# Cheekye Panel Report

Squamish Council

July 15, 2014

John Clague P.Geo.

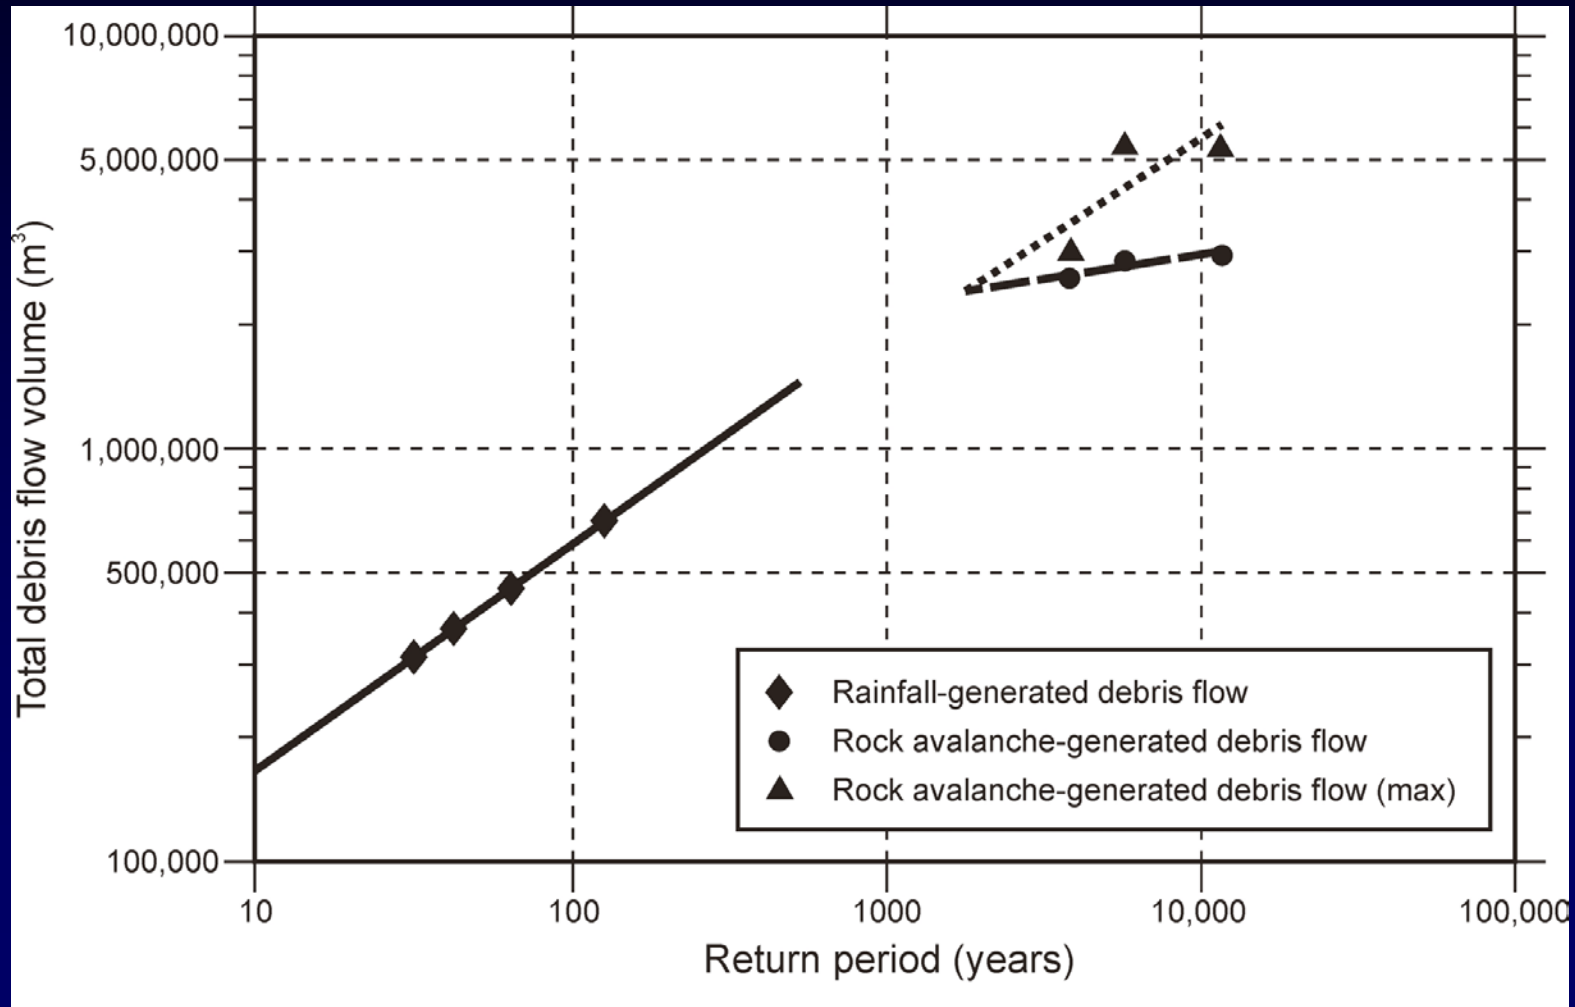
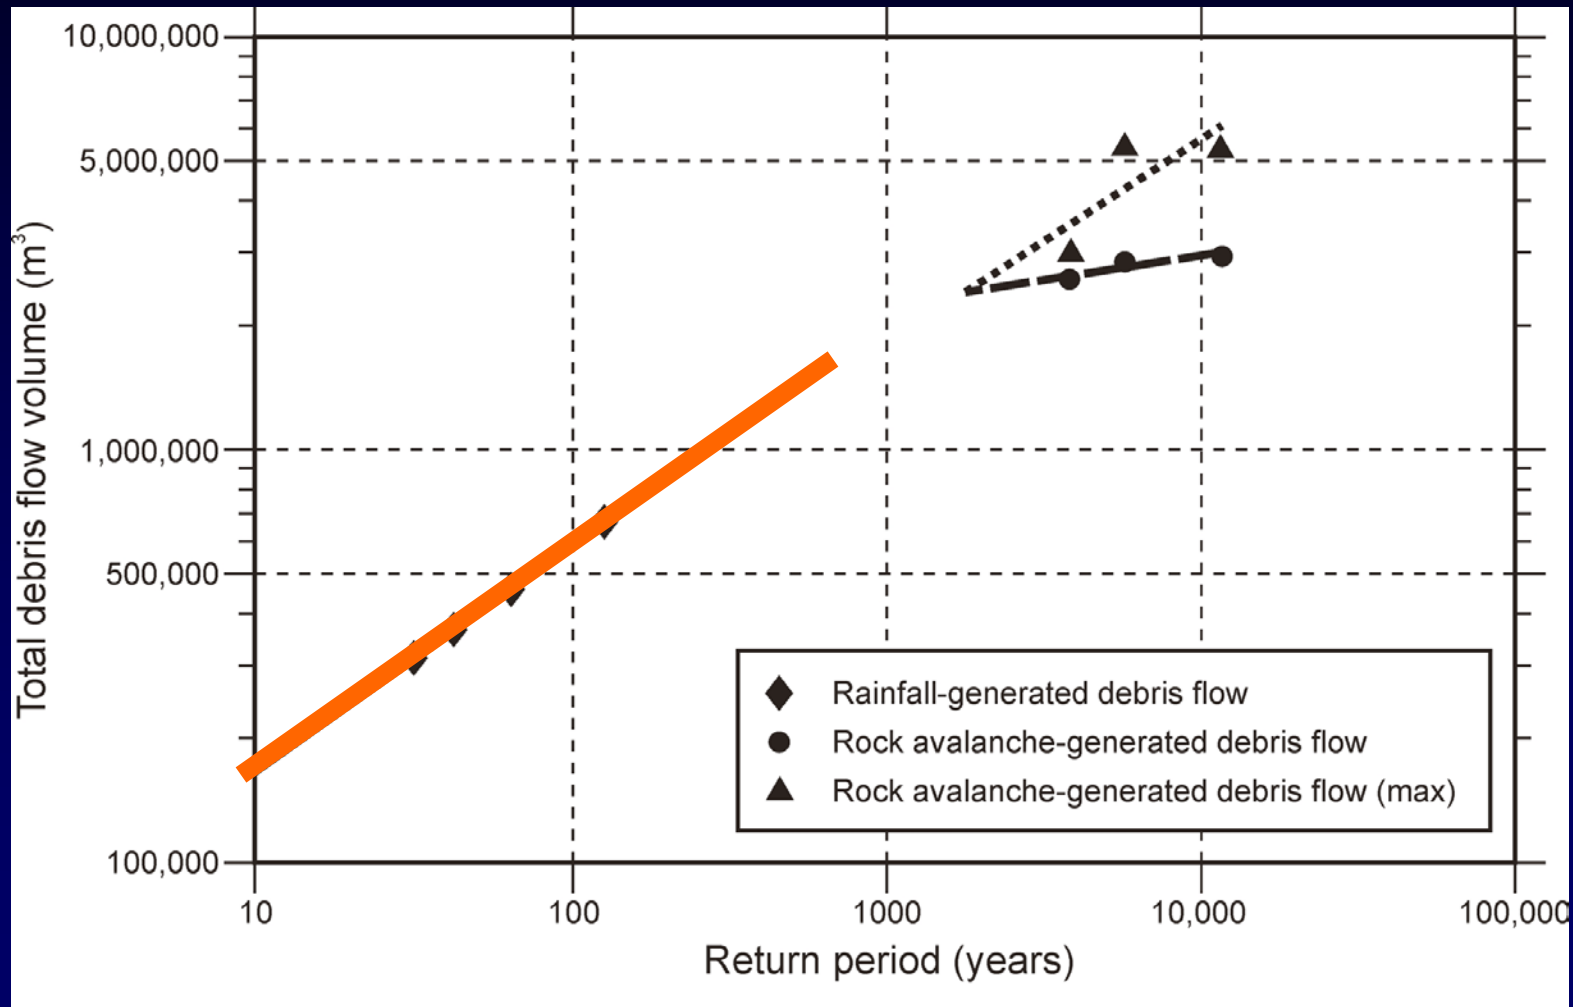
- The Panel's opinion is that BGC's MCF relationships are the most reliable MCF relationships currently available for Cheekye Fan ...

...The solid line on the left side of the MCF curve is credible and could be a basis for debris flow mitigation strategies for this range of smaller volume, rainfall/surface water runoff-generated debris flows.

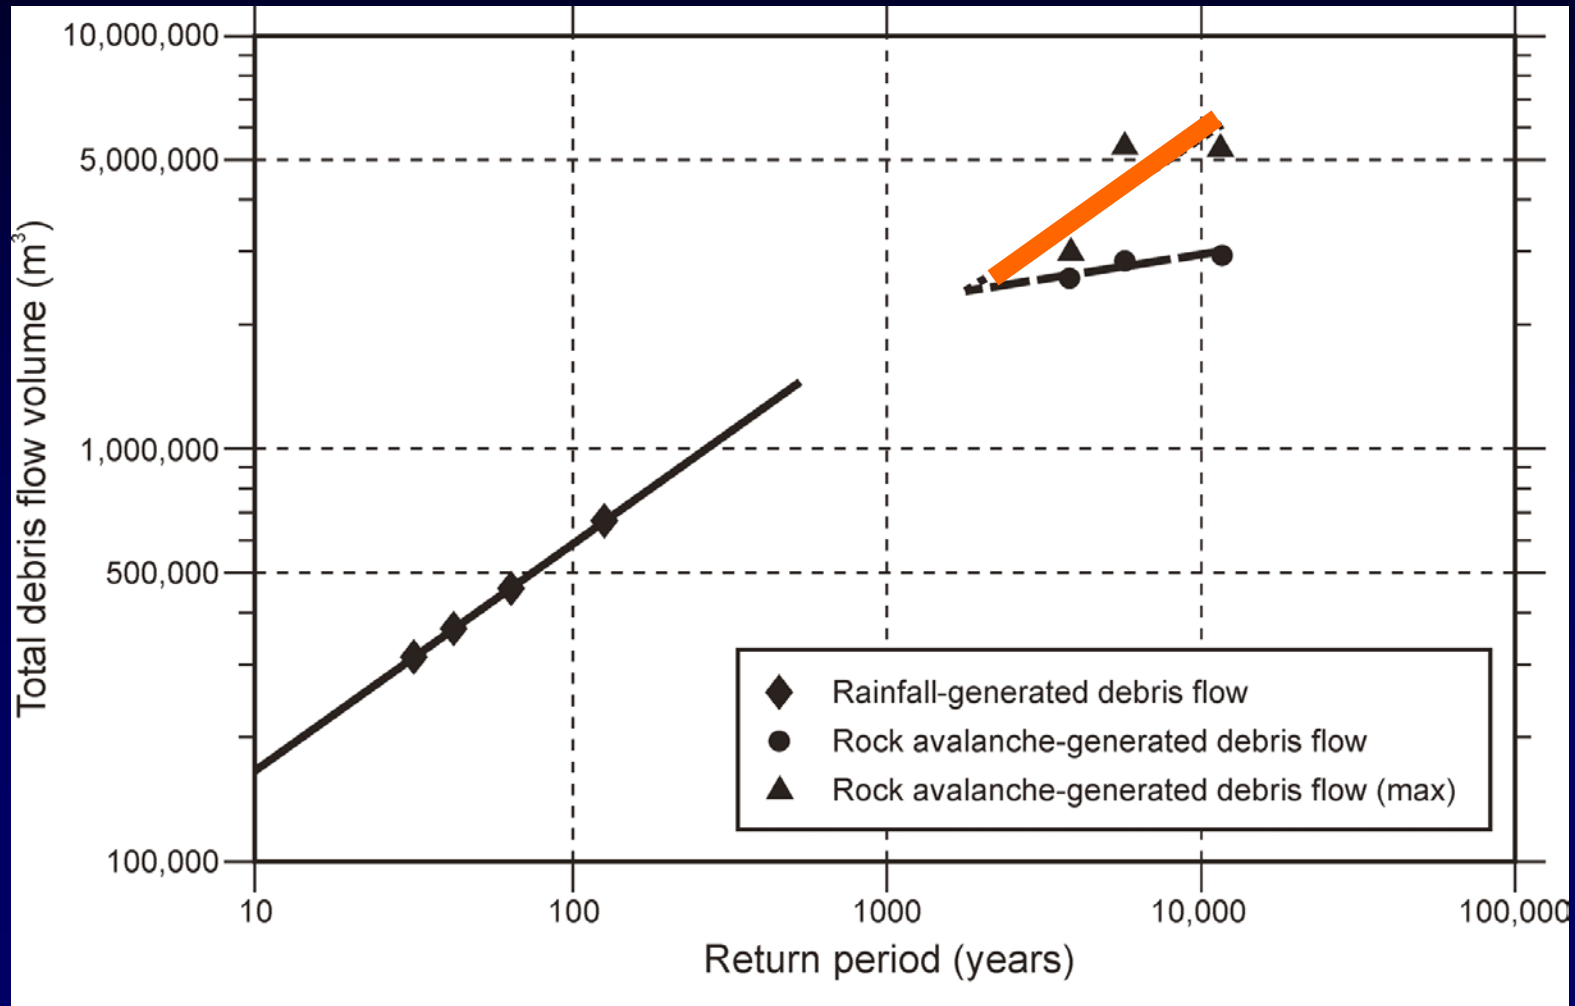
- The Panel's opinion is that the upper (orange line on the right side of BGS's MCF relation) provides a prudent estimate of the largest volume of debris that could be transported to Cheekye Fan during a rock slide-generated debris flow. The volume of this 1:10,000-year event is 5.5 million m<sup>3</sup>

- This estimate is more conservative than was recommended by BGC (2008), but is consistent with several previous estimates, as reviewed in the Panel's report, and considers the unknowns, uncertainties, and assumptions discussed in the report, specifically...
- *A reliable estimate of the 10,000-year event requires a record that spans more than 10,000 years. The Cheekye watershed record spans only 10,000 years. Therefore a statistical estimate evaluation of the 10,000-year debris flow cannot be relied on and estimates of future potential must be based on professional judgment*
- *The right side of BGC's MCF relation is based on three debris flows, only the smallest of which can be quantified with some reliability, as discussed by BGC (2008). The volume of either of the other two debris flows could have been as large as 5.5 million m<sup>3</sup>*

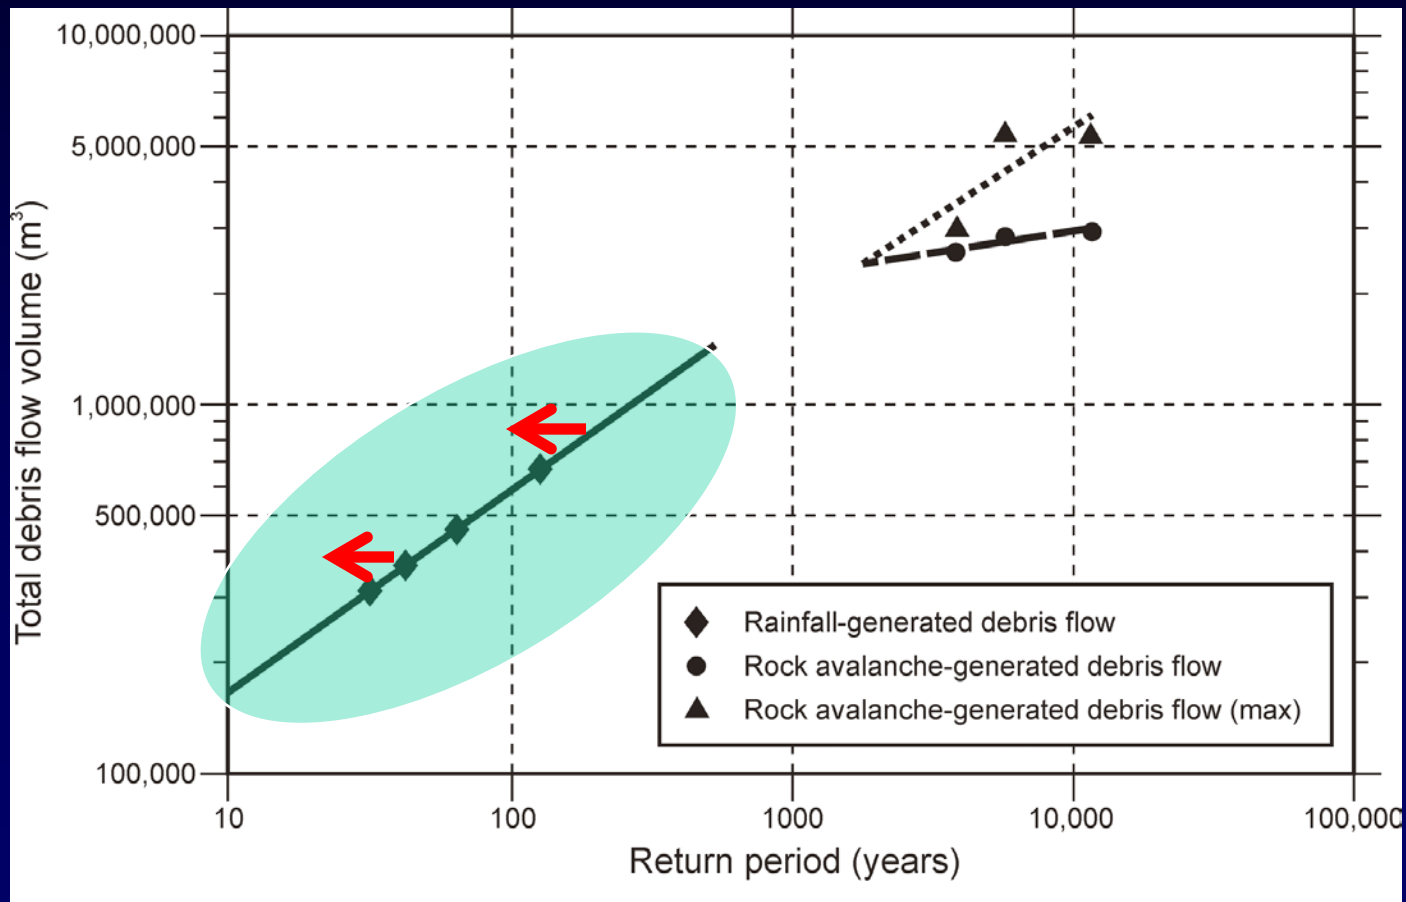
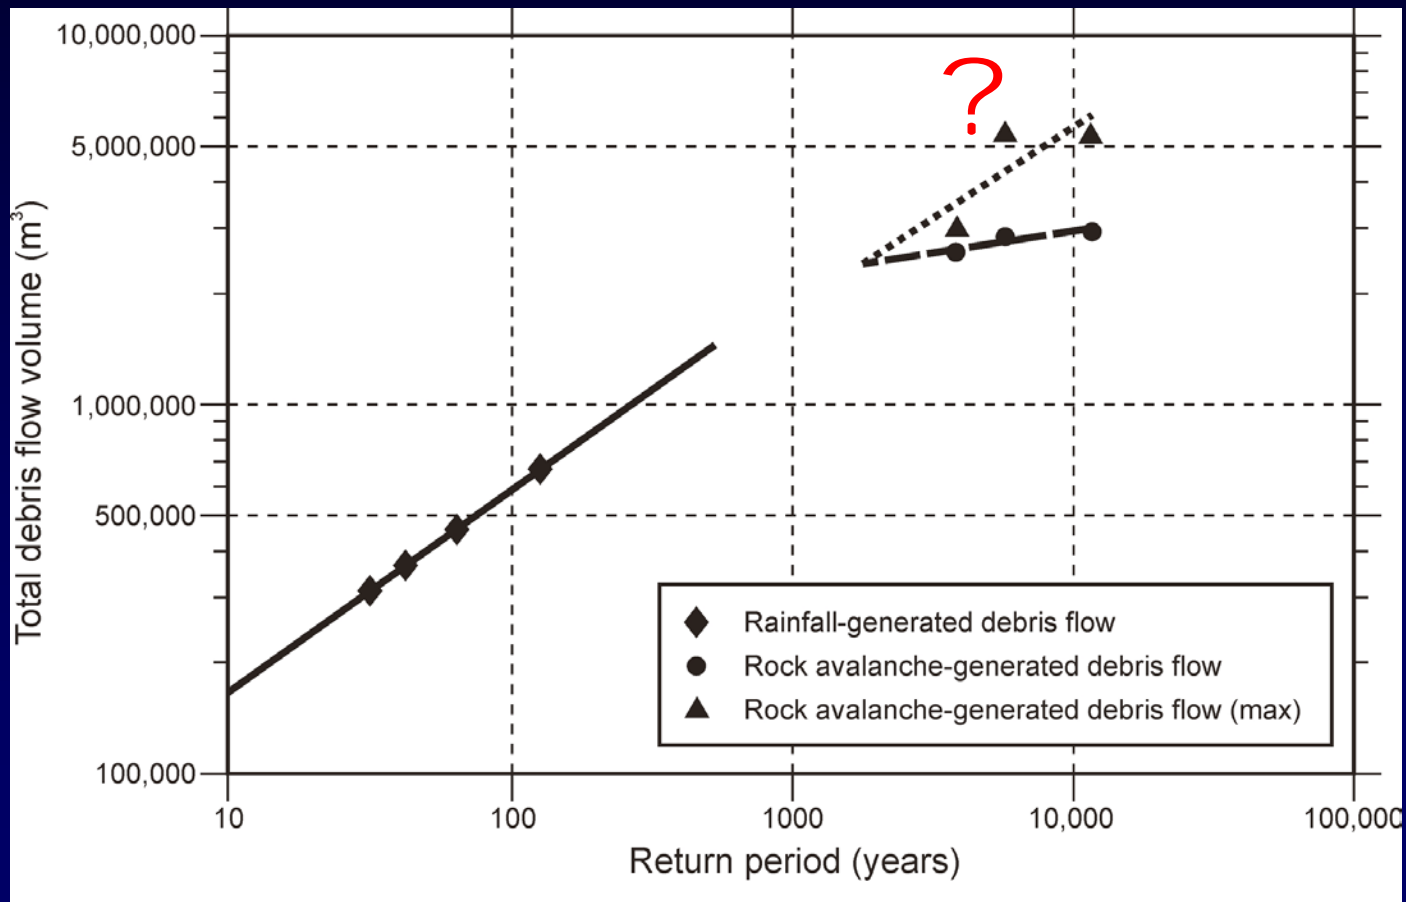
- The Panel's opinion is that climate change might increase the frequency of smaller rainfall/water runoff-generated debris flows and debris floods, consistent with the conclusion of BGC (2008). This expectation would shift the solid line on the left side of the BGC MCF plot to the left, although by how much is unknown

- The Panel's opinion is that climate change **might** increase the frequency of major rock slide-generated debris flows, shifting the lines on the right side of the BGC MCF plot to the left. This shift would have the effect of increasing the volume of the 10,000-year event. This outcome, however, is uncertain

- Possible climate change effects must be dealt with by selecting suitably conservative parameters during the design of any mitigation measures, and by selecting solutions that are flexible with respect to the magnitude of potential effects
